REED'S COVE 3RD ADDITION

RE: SUB 2004-08 -- Final Plat of Reed's Cove Third Addition

At the regular meeting of the Subdivision Committee of the Metropolitan Area Planning Commission on Thursday, February 26, 2004, the above captioned plat was considered. The action of the Committee was to approve the final plat, subject to the following staff comments:

CASE NUMBER: SUB 2004-08 -- REEDS COVE THIRD ADDITION

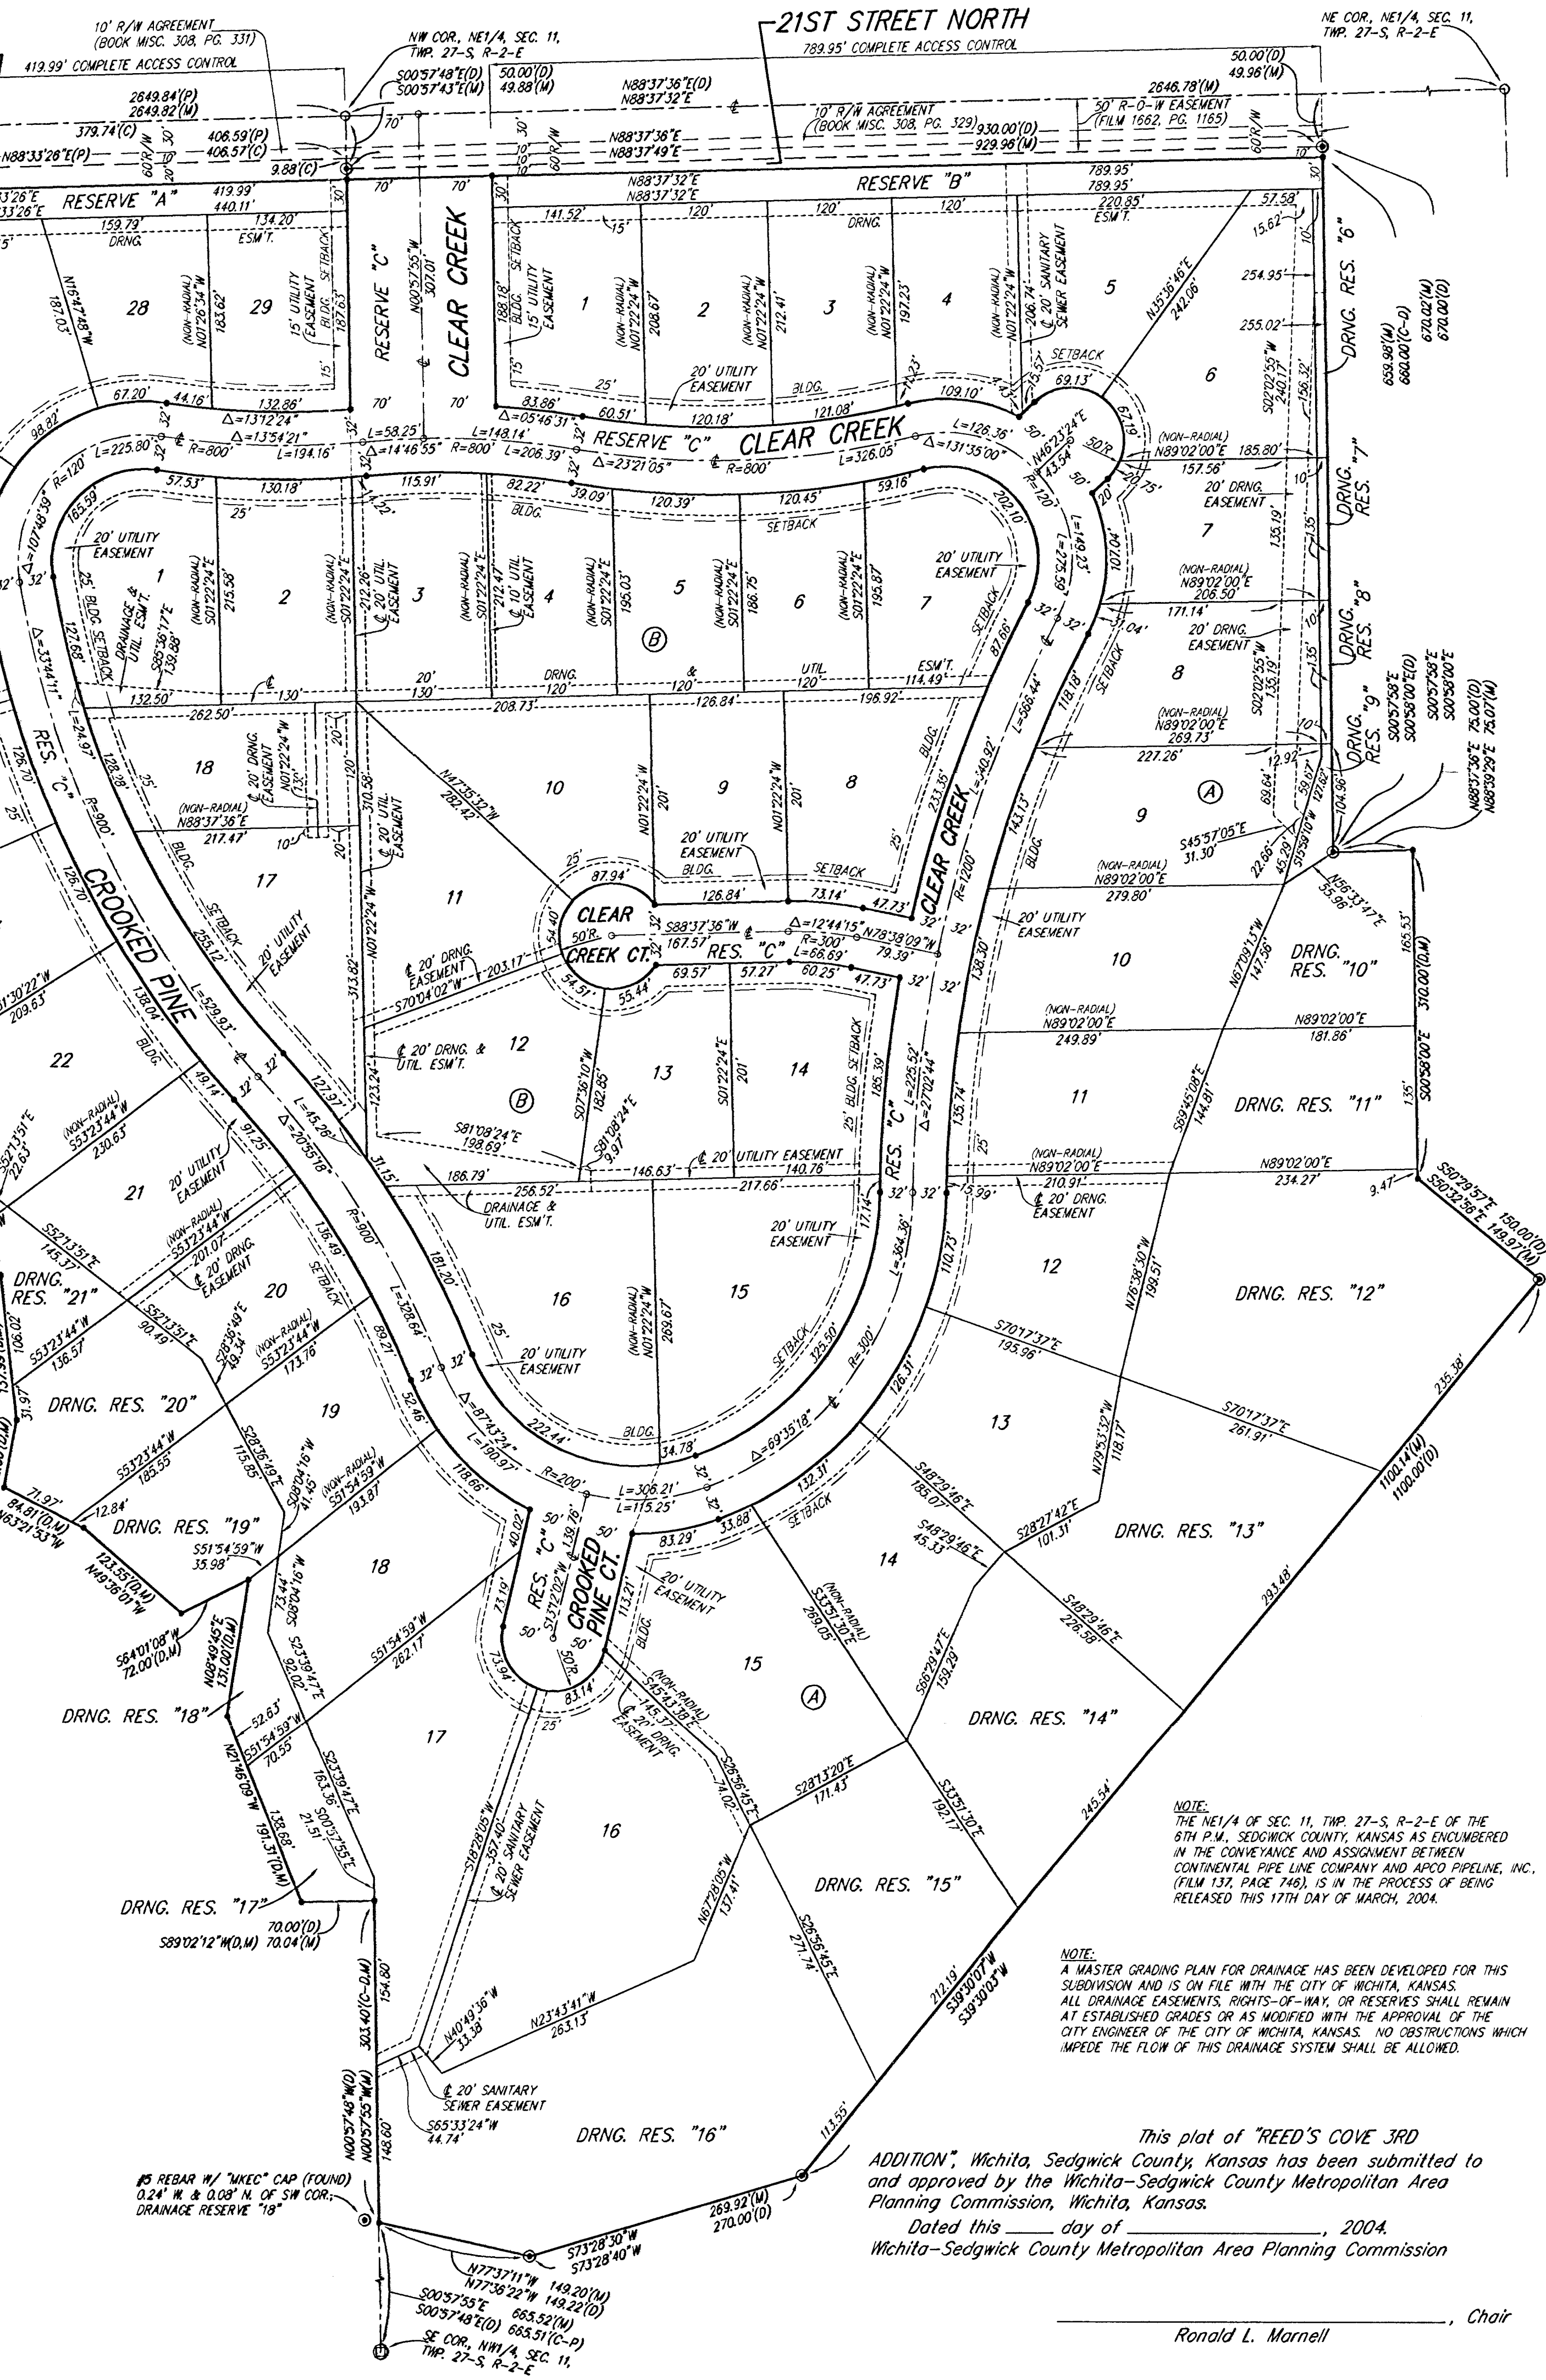
- A. Prior to this plat being scheduled for City Council review, annexation of the eastern portion of the property will need to be completed. Upon annexation, the property will be zoned SF-5, Single-Family Residential.

- B. The applicant shall guarantee the extension of sanitary sewer and City water to serve the lots being platted. City Water and Sewer Department and OCI have requested an agreement which limits sewer connections based upon capacity.

- D. City Engineering needs to comment on the status of the applicant's drainage plan. The drainage plan is approved. A guarantee is needed.
- E. Traffic Engineering has requested a petition for a left-turn lane.

- F. The applicant shall guarantee the paving of the private street to the urban street pavement standard. As private improvements, such guarantee shall not be provided through the use of a petition.

- G. City Fire Department has requested a 35-ft roadway be provided at the street entrance. In the event a median is used, a 20-ft roadway for ingress and 29-ft roadway for egress shall be provided. If a gated development is proposed, a siren-activation gate is needed.

- H. The paving guarantee shall also provide for sidewalks on one side of the loop street.

- I. A covenant shall be submitted regarding the private street, which sets forth ownership and maintenance responsibilities. The plat's text shall reference the platting of the reserve for private street purposes and shall state which specific lots are to be accessed by the reserve.

- J. The reserves being platted as private streets shall be shown appropriate street names.
- K. In accordance with the KS Wetland Mapping Conventions under the Memorandum of Understanding between the USDA-NRCS; USEPA; USACE; and USF&WS, this site has been identified as one with potential wetland hydrology. The US Army Corps of Engineers (USACE) should be contacted (316-322-8247) to have a wetland determination completed."

- L. Provisions shall be made for ownership and maintenance of the proposed reserves. The applicant shall either form a lot owners' association prior to recording the plat or shall submit a covenant stating when the association will be formed, when the reserves will be deeded to the association and who is to own and maintain the reserves prior to the association taking over those responsibilities.

- M. For those reserves being platted for drainage purposes, the required covenant which provides for ownership and maintenance of the reserves shall grant, to the City, the authority to maintain the drainage reserves in the event the owner(s) fail to do so. The covenant shall provide for the cost of such maintenance to be charged back to the owner(s) by the governing body.

- N. The drainage reserves "20" through "29" need to be referenced in the plat's text.
- O. GIS needs to comment on the plat's street names. *The entrance should be Clear Creek. The loop street should be Crooked Pine and Clear Creek.*

- P. A bold solid line is needed between the 21st St. North right-of-way line and Reserve C.
- Q. County Surveying advises that the benchmark needs a better description.

- R. The Applicant needs to verify the location of the pipeline easement indicated in the platting binder. The easement shall be shown if encumbering this plat, or verification provided that it is off-site or has been released.

- S. The plat's text shall include language that a drainage plan has been developed for the plat and that all drainage easements, rights-of-way, or reserves shall remain at established grades or as modified with the approval of the applicable City or County Engineer, and unobstructed to allow for the conveyance of stormwater.
